Preparatory/review study - Annex H

Commission Regulation (EC) No. 643/2009
with regard to **ecodesign requirements for
household refrigeration appliances**
and
Commission Delegated Regulation (EU) No.
1060/2010 with regard to **energy labelling of
household refrigeration appliances**

FINAL REPORT – ANNEX H

This annex contains full text of stakeholder comments

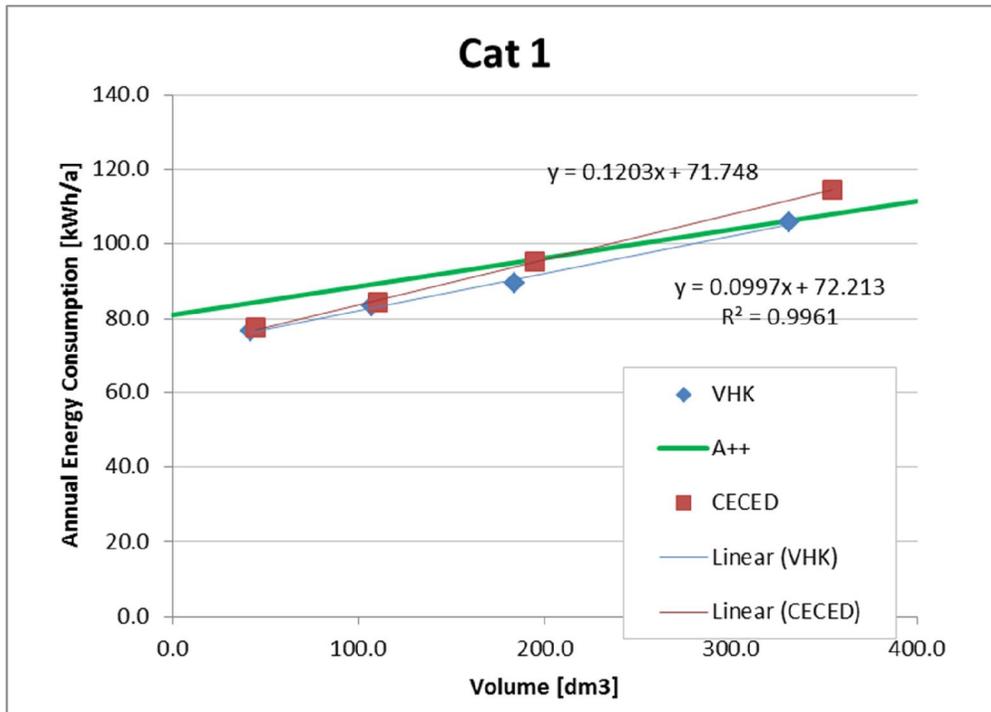
The following modifications are suggested to the model:

- a) Correction of area and volume
- b) The wall thickness of appliance 4 has been reduced from 70 to 65 mm. The spreadsheet contains the 70 mm data as well (Column 4A) which has 4.9 % less volume and 5.9 % more consumption. (The specific heat loss is therefore practically the same). Column 4B has been added using the optimal wall thickness, being 82 mm in this case. For similar reasons the wall thickness for appliance 3 has been reduced from 53 mm to 50 mm.
- c) Nominal cooling capacity has been made a function of product size. All these products should have to match a highest ambient specification which requires different capacities for each.

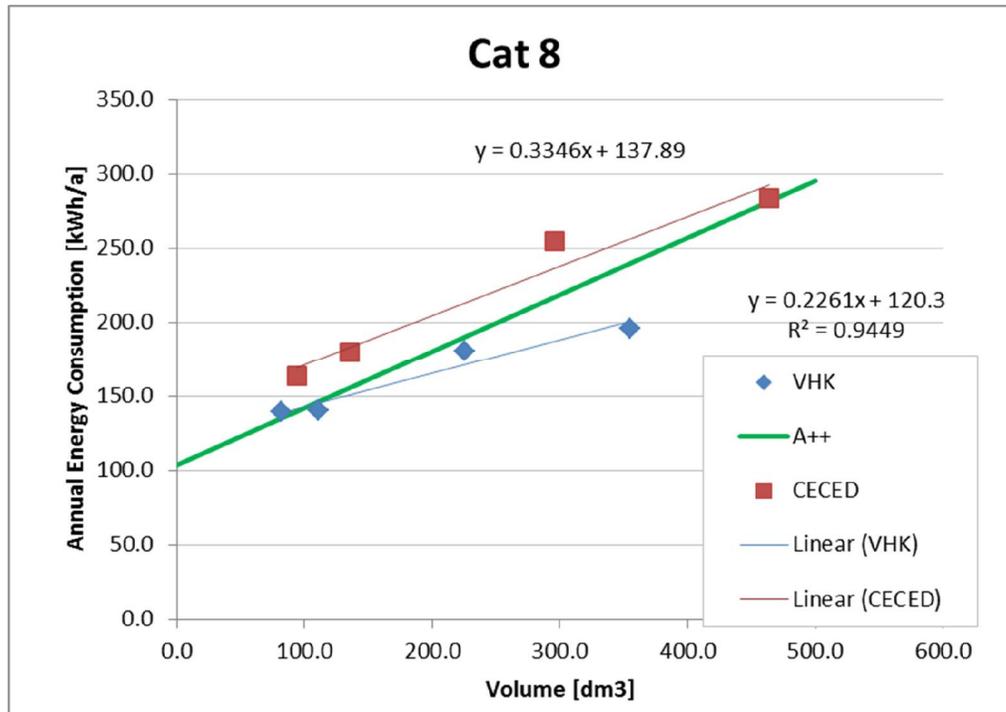
Again, a figure is shown with the report data and the results using the modifications. Compared to the VHK data the modifications result in a steeper curve, which is believed to be more realistic. Compared to the present A++ line the curve is somewhat more flat.

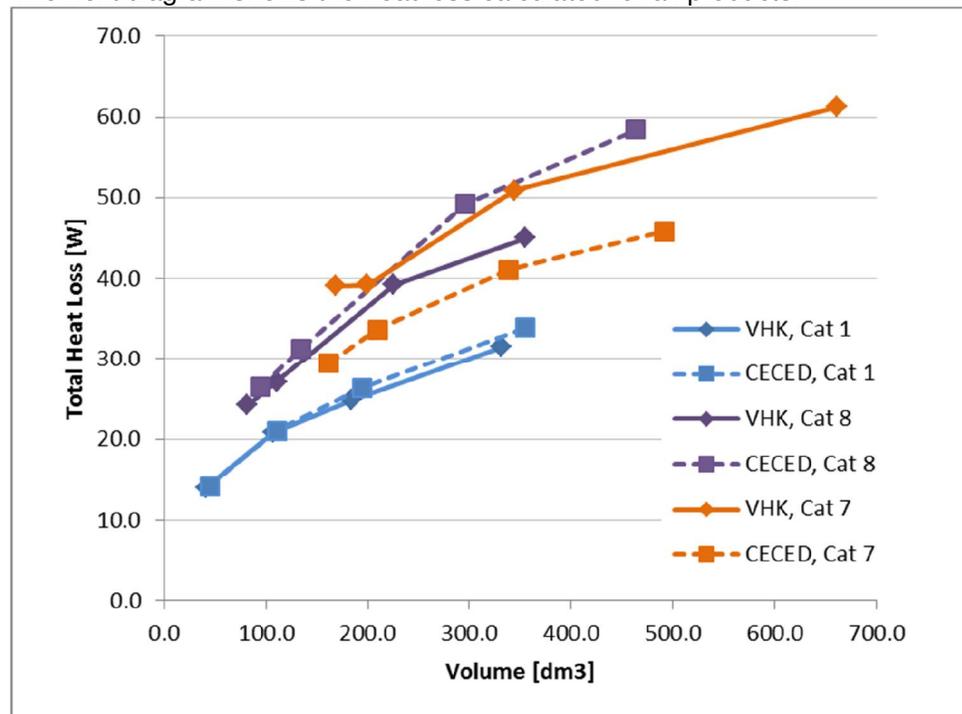
The next diagram shows the heat loss calculated for all products:

As can be seen, the combi according the CECED data is approximately midway between fresh food and freezer, while in the original VHK model, the heat loss of the combi was actually higher than for the freezer (at the same total net volume).

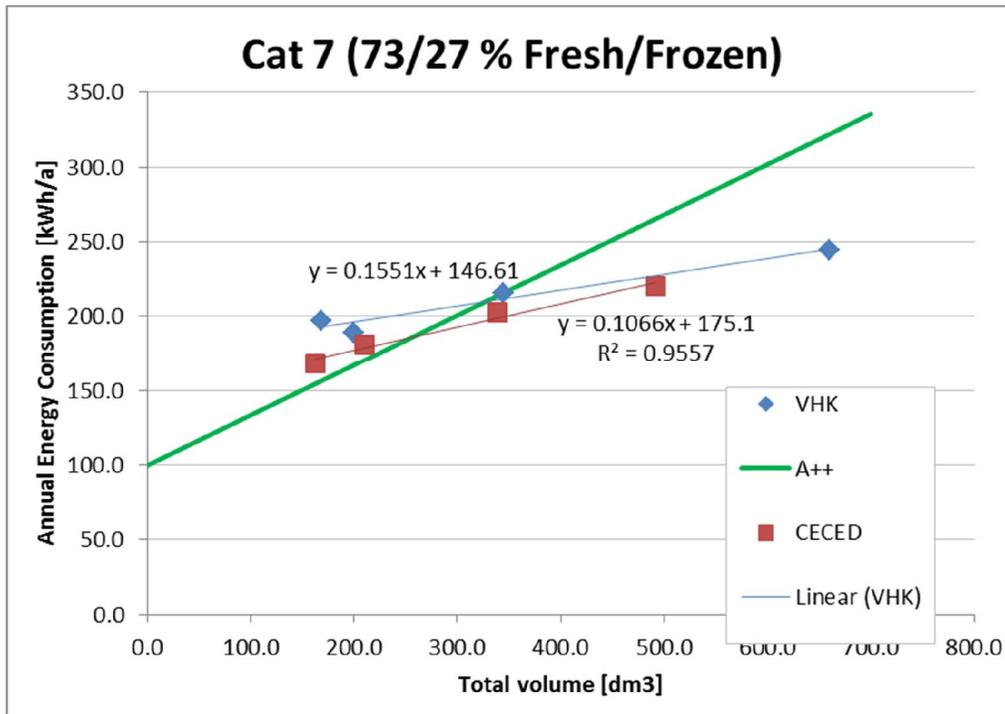
Next figure shows the report data (“VHK”) and the results using the modifications (“CECED”):

Compared to the VHK data the curve is now more steep, bit still significantly flatter than the current A++ curve, so larger appliances are penalised compared to today.

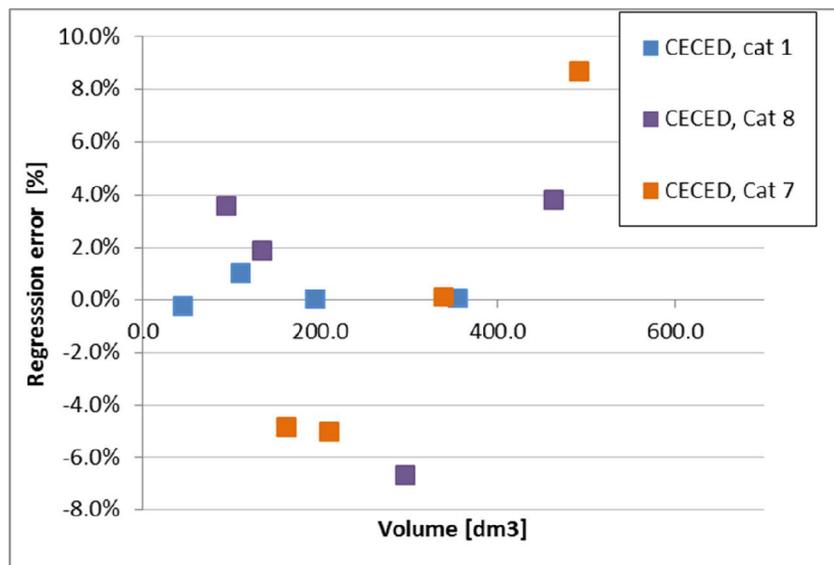
Various attempts have been made to work with the VHK reference formula or variations of it. This includes the formula's presented in version V2 of this note, which was recognised later to have several shortcomings as well as the formula presented in the report. In order to get good fits of the VHK reference formula with the technical model a high value of the coefficient C1 is required⁸. The following set of data has been derived and regression errors are shown in the chart:

On itself there is reasonable agreement, but there are some concerns:

- a) The coefficient 1.35 lacks a good physical meaning, but it is the result of the formulation chosen.
- b) If a combi is constructed of two fresh food compartments (or of two frozen food compartments), the coefficient C1 leads to a large bonus.

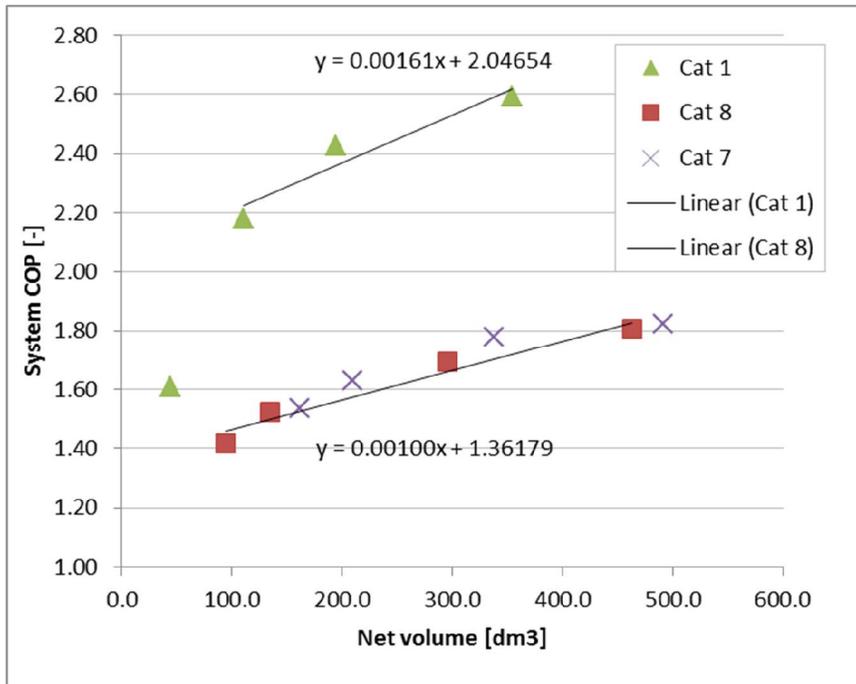
and with M=0.47 and N=127 a reasonable fit has been obtained. The largest freezer has been excluded from the regression in order to get a better fit for the more popular freezers sizes.

Note that the heat load of the combi is actually above this line for three of the four products, which is caused by the choice of the wall thicknesses to be the same as for the same net volume stand-alone fridge or freezer.

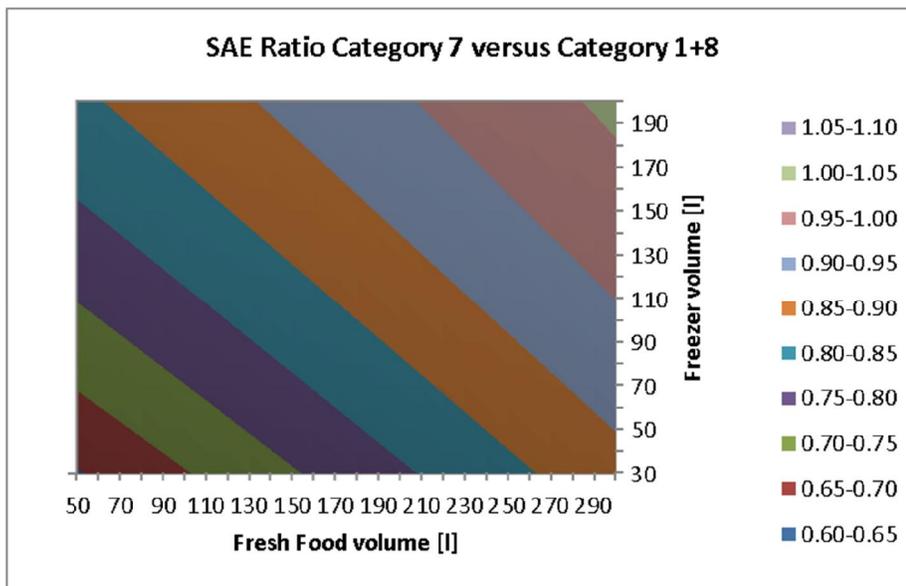
Note that in the current regulation the SAE for a combi also deviates strongly from the added SAE values of the single appliances as shown below:

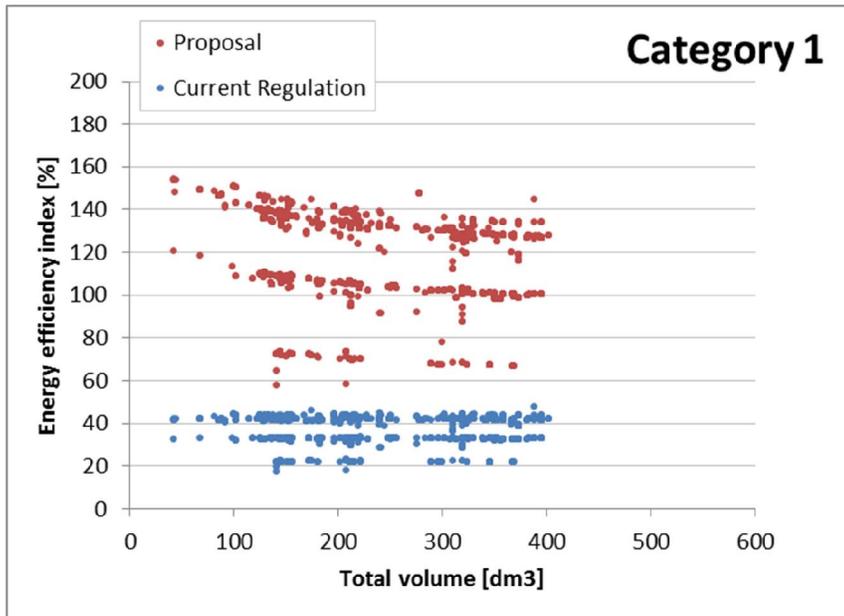
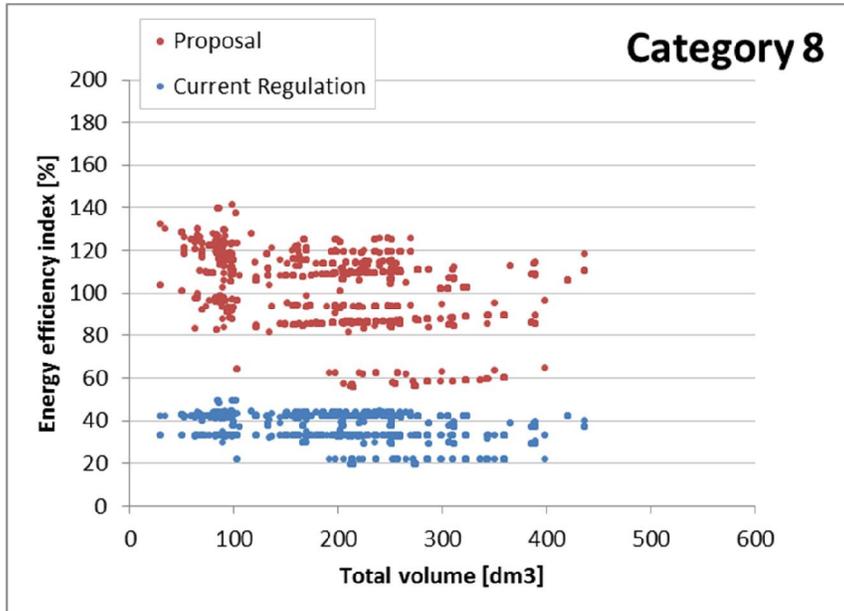
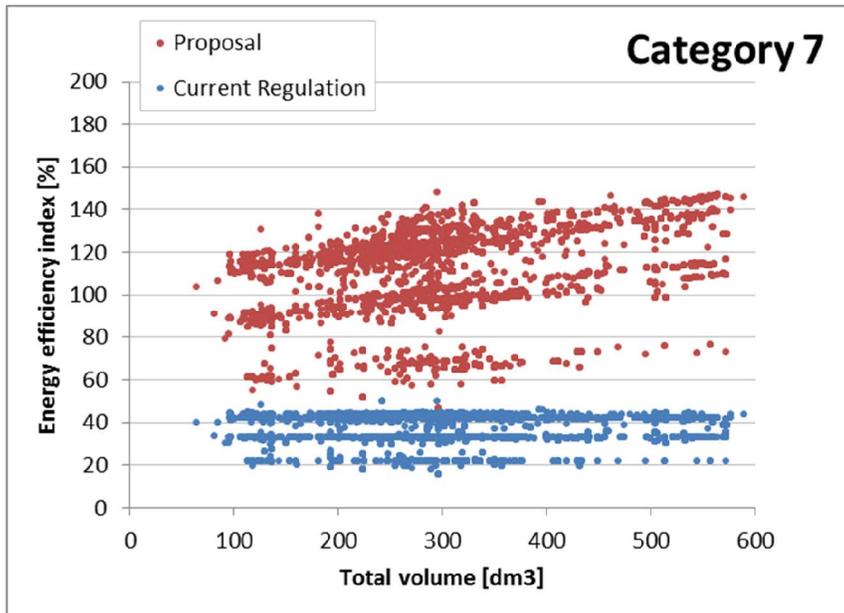
Using the above definition of the reference line it is possible to plot the energy efficiency index as a function of total volume and compare this to the actual energy efficiency indices. This is done using the CECED database 2015 (listed as database 2014 within CECED). Separate figures are made for cat 1, 7, and 8. In all cases the compensations as listed in the report have been applied (note that this means that no

For these products the index 100 corresponds roughly with current A++ appliances. However, using the new standard the consumption will increase.

For category 8 the index of 100 correlates with the current appliances between A+ and A++. Due to the new standard the standard energy consumption needs to be reduced so the indices will increase somewhat.

The final result on category 7 shows a steep increase as function of the volume. A limit at index 100 would cancel out all current A++ appliances with a total volume larger than app. 300 litre (uncorrected for the global standard). If the combi factor of 1.2 would not have been introduced then the complete group of A++ appliances would be above 100.

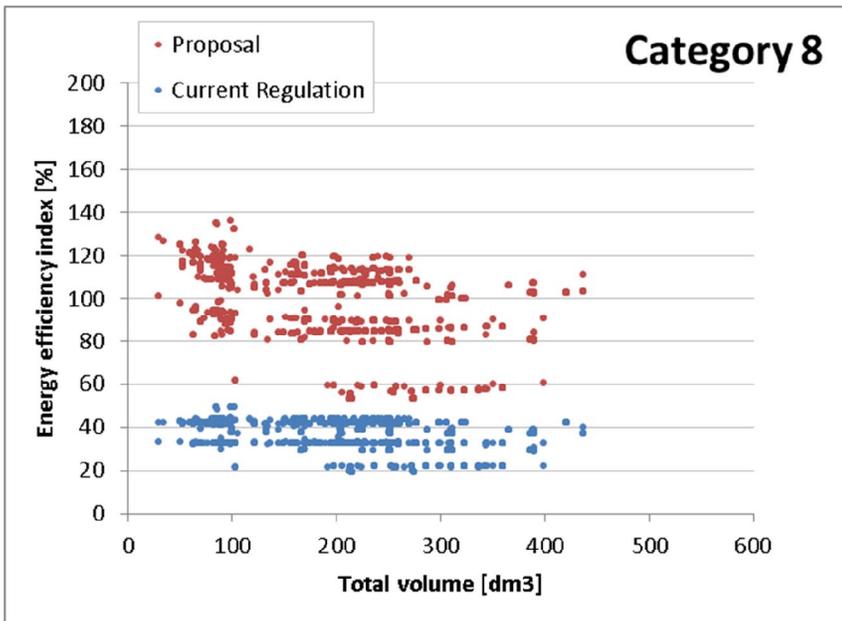
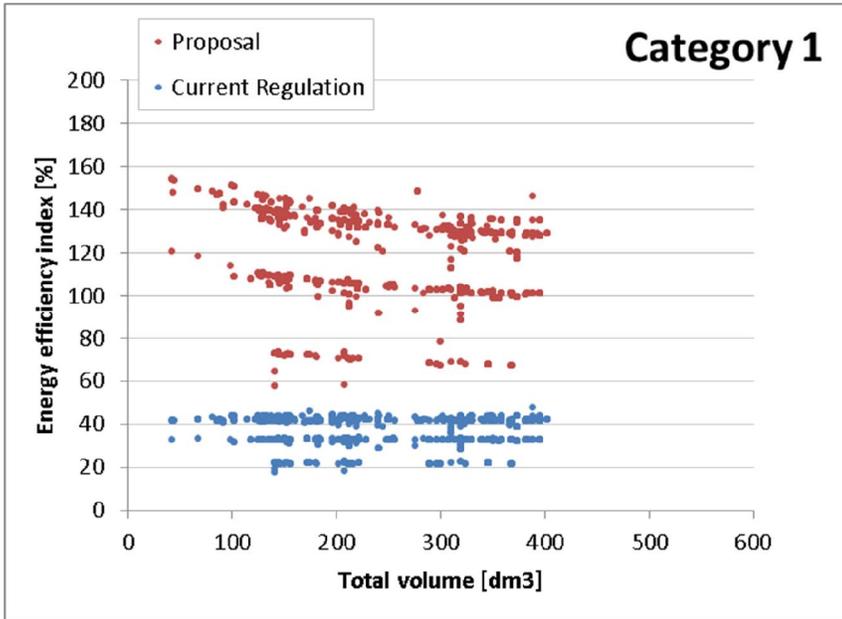
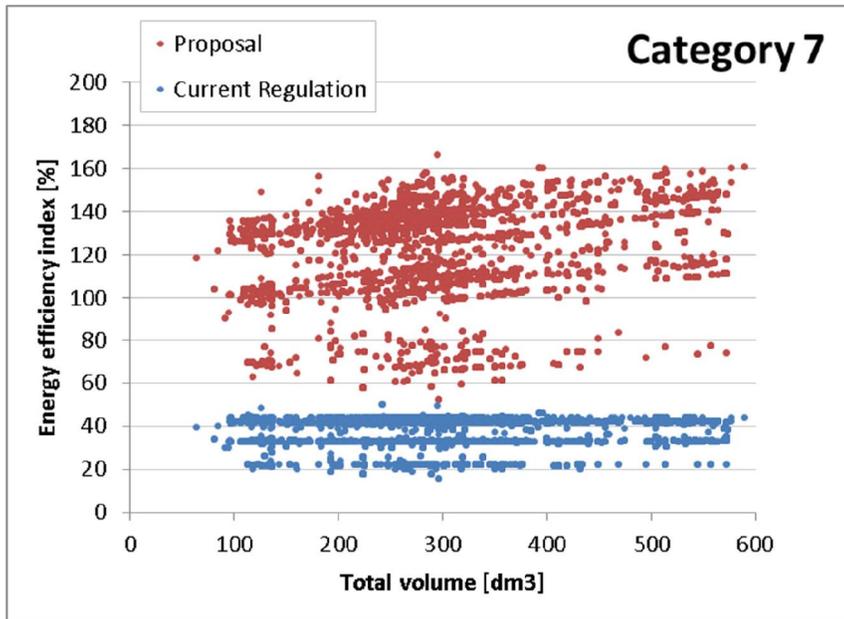
The following charts show the effect for the different categories:

Compared to the previous analysis before using the new global standard following observations can be made:

- a) The picture for the fridges remains approximately the same as expected.
- b) The freezers have also remained more or less the same
- c) For the combi there is more dispersion between the data points, caused by the different correction for type I and type II appliances. On average the indices have increased due to the fact that the reference model under predicted the technical model here.
